Re: Response to January 23rd letter

Single Unit
Model No. SN-100

This letter is in response to your resubmittal dated December 28, 1995, requesting registration of the Model SN-100 Series and SN-500 Series smoke detectors. We are in the process of re-evaluating your request. However, in order to continue our evaluation, the following information is necessary:

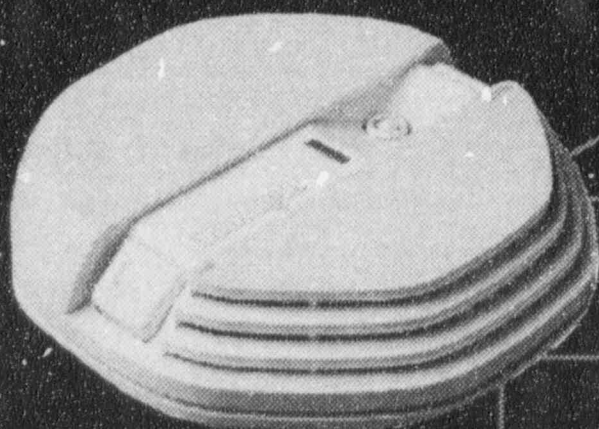
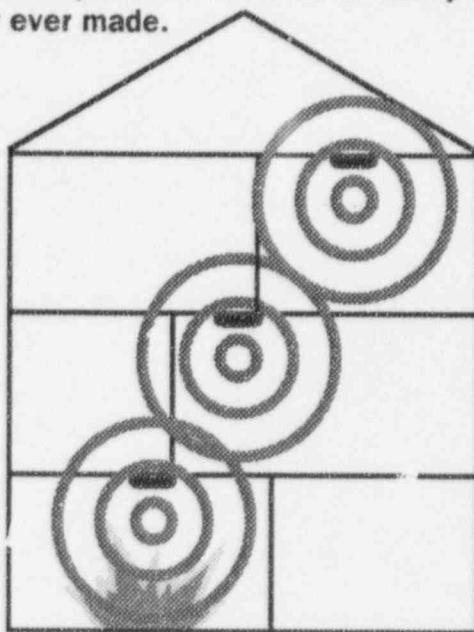
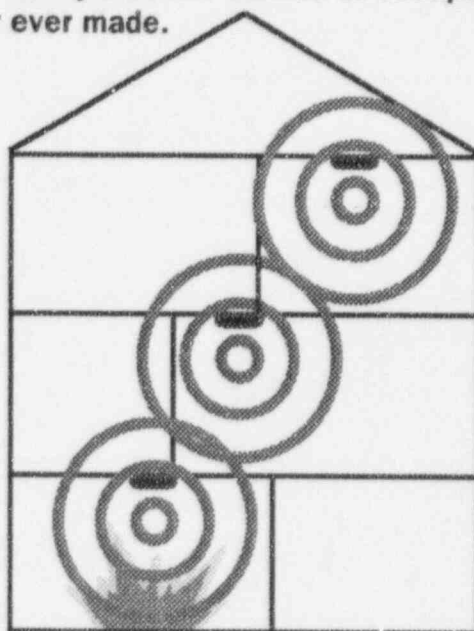
Please provide samples or full-scale drawings of the ion chamber and point-of-sale package labels.

- 1) The referenced screw does penetrate the source support and not the source holder
- 2) Method "A" is the only method submitted. There is no other method with this submission.
- 3) Ion chamber label - attached is a scaled sample. The label in use may have either square or rounded corners or different font type text.

Point-of-purchasing markings - attached is one possible marketing scenario. While everything else on the package is subject to marketing revision, the NRC verbiage there will remain the same size.
